**HEIERMAN - HISTORIC LANDMARK COMMISSION REVIEW**

## The Heierman Building

115 E. 5th Street  
Austin, TX 78701  
Travis County

Re: Recorded Texas Historic Landmark project review, Heierman Building, 115 E. 5th Street, Austin, Travis County, Texas (RTHL 14733)

Section Diagram showing limited visibility of the rooftop addition from accross the street. Reference image fig. 24 from National Park Service - Preservation Brief 14 - Rooftop Additions.

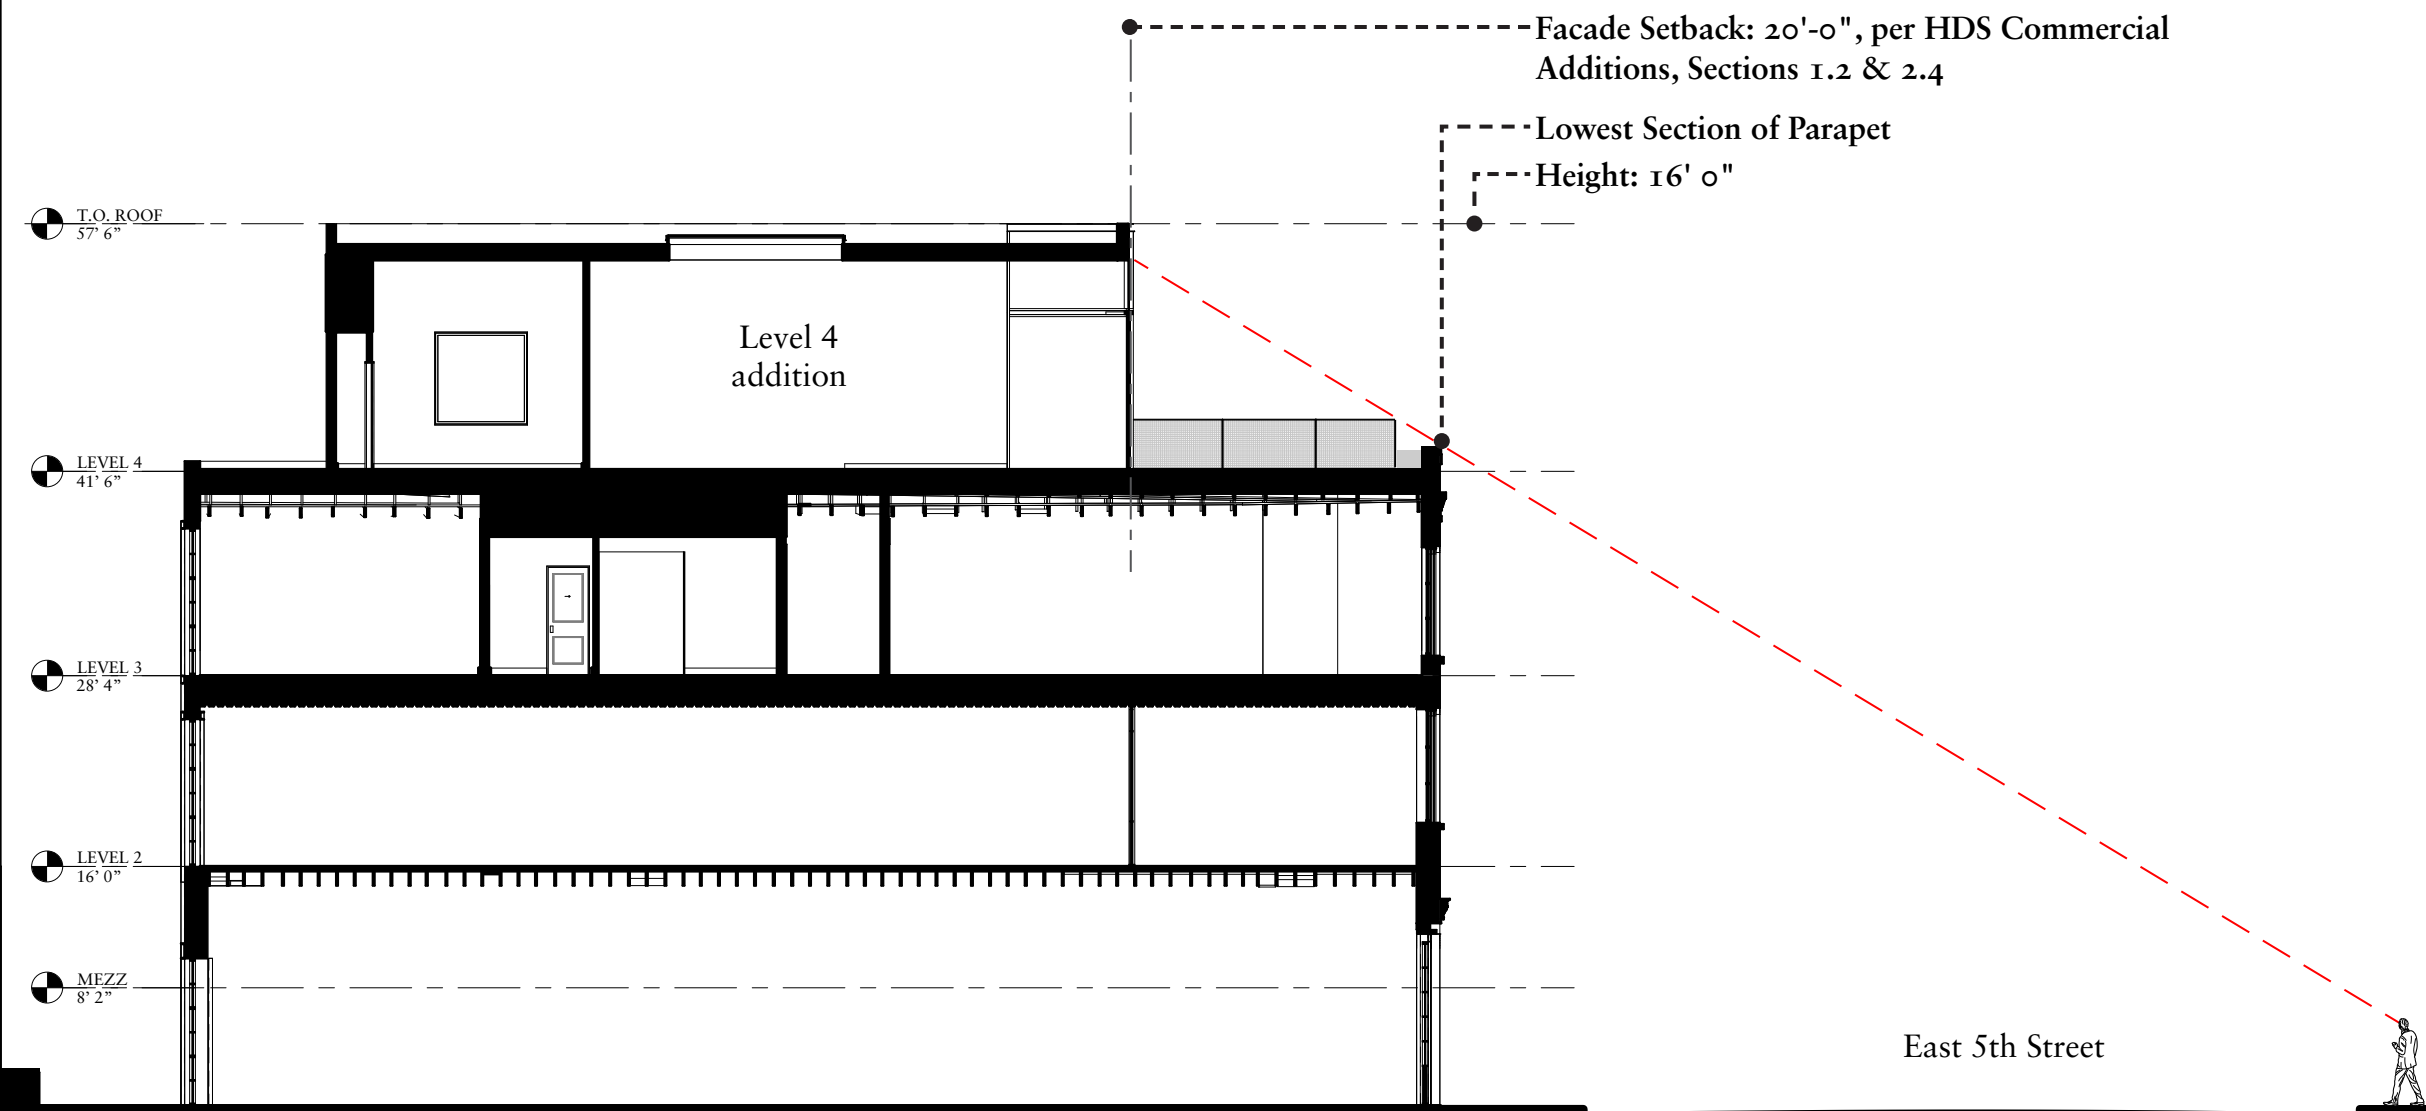
Regarding the proposed rooftop addition, our staff appreciates the architect providing the sight line diagram and accordingly setting the associated new construction twenty feet back from the primary façade’s parapet to reduce visibility of the new addition from the principal perspective across 5<sup>th</sup> Street. Yet, our staff recommends the new addition being lowered in height to be more commensurate to the approximately 12’-13’ heights of the historic second and third stories of the building. Furthermore, our staff recommends and expects the proposed steel paneling of the new addition to be painted a lighter color to blend in more with the existing buff colored historic brick of the Heierman Building and the light grey concrete color of the parking garage directly behind the building to the south.

Proposed Design

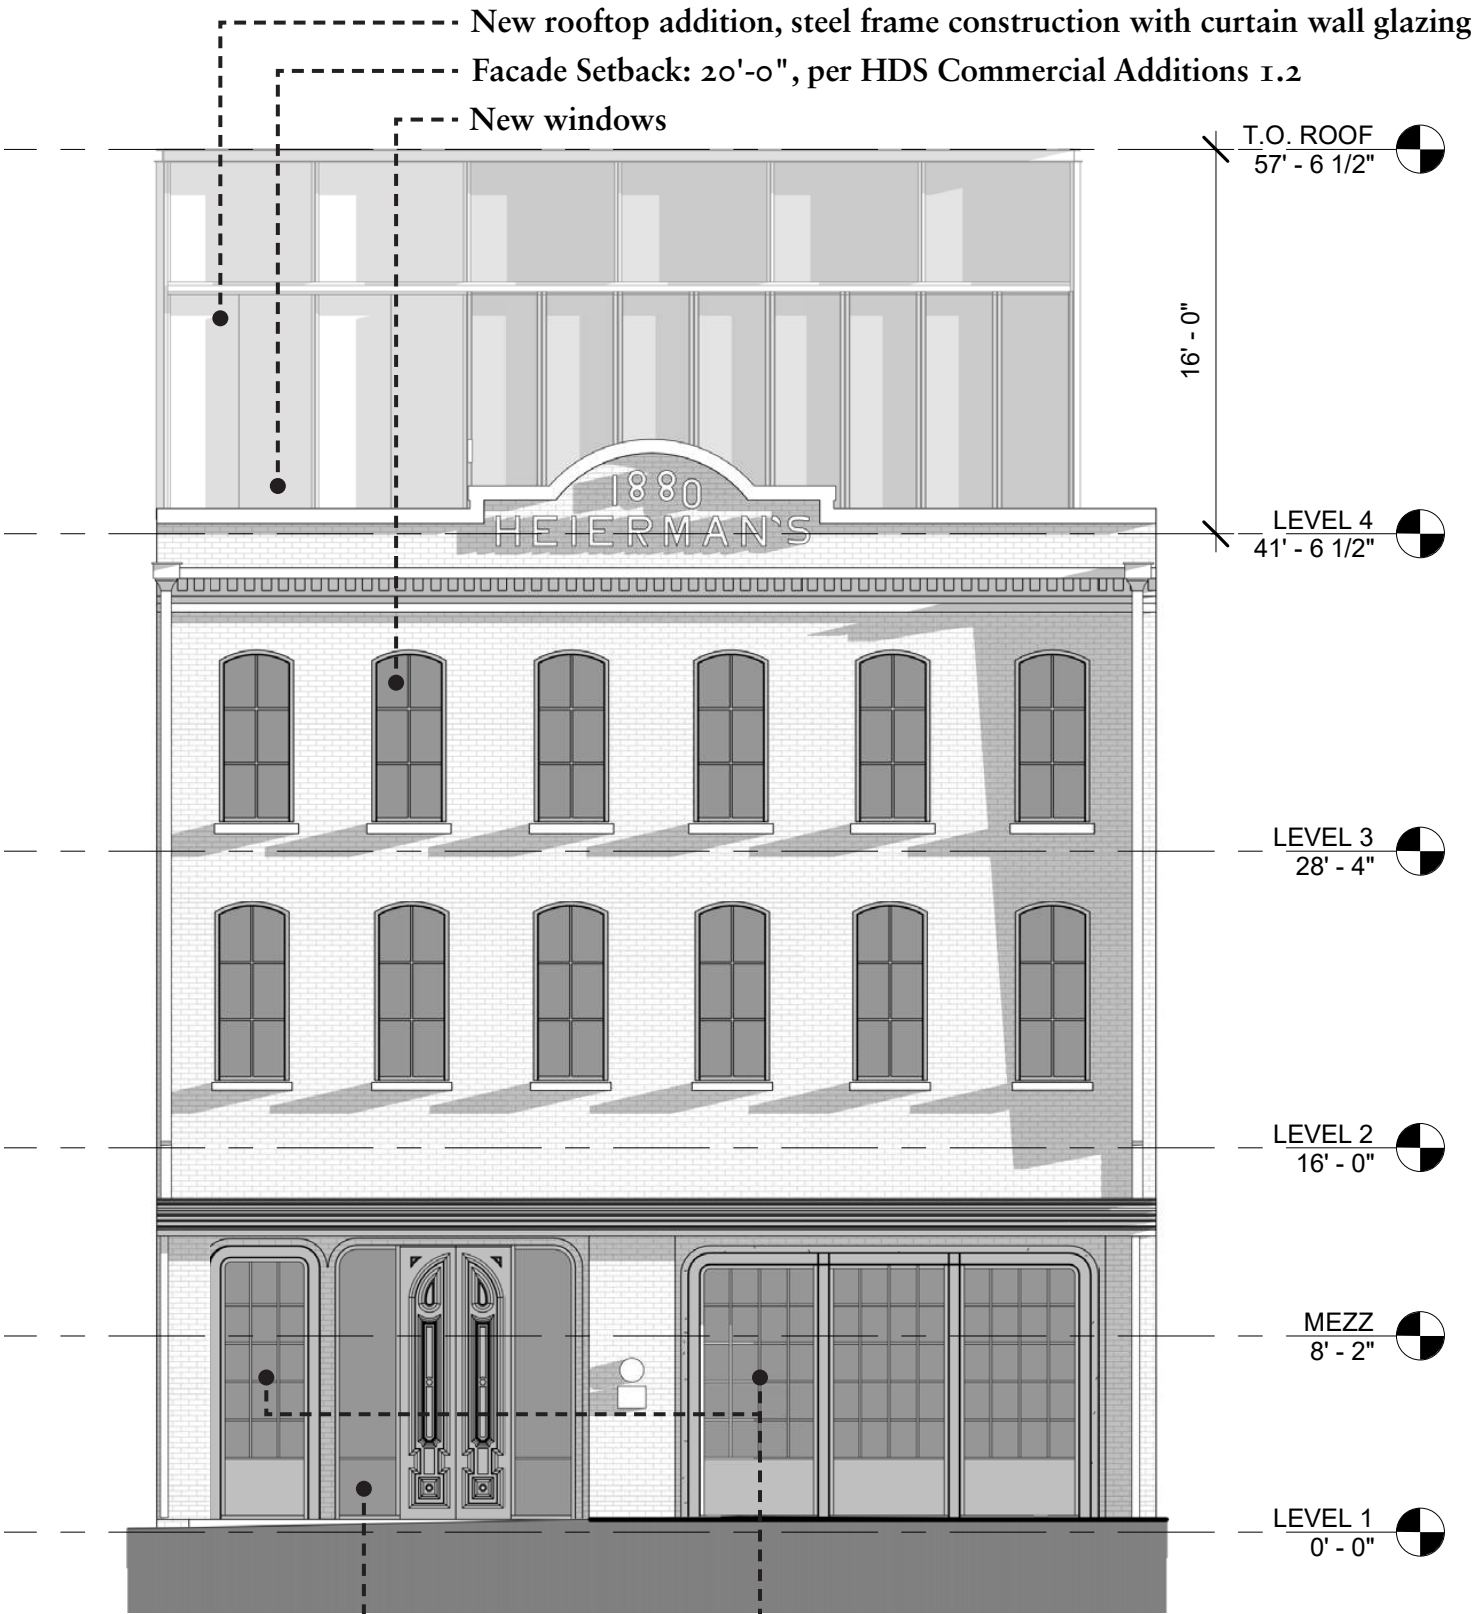
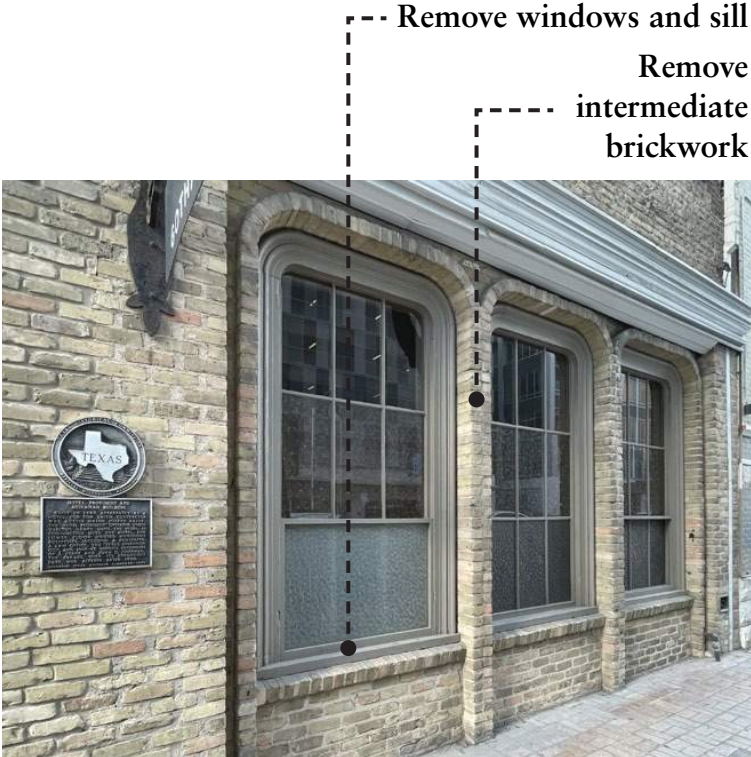
Furthermore, although the 1974 appearance of the building was referenced as a rationale for the proposed inset reconfiguration of the primary façade, the architectural condition of that portion of building had already been significantly altered and would not be considered historically significant, despite the Recorded Texas Historic Landmark designation having been awarded at that time. Similarly, the planned alterations to the rear, south elevation are not a recommended approach due to the extensive removal of original historic brick masonry and original fenestration openings that is proposed. Yet, due to the severity of inappropriate changes to the building over time, along with the most extensive alterations proposed being on the rear elevation and therefore not visible to the public, our staff will not be making a recommendation to pursue removal of the RTHL designation in the case that the current design plans are carried out. Our staff does recommend salvaging and storing (for potential future reuse), as much of the historic material planned for removal as possible.
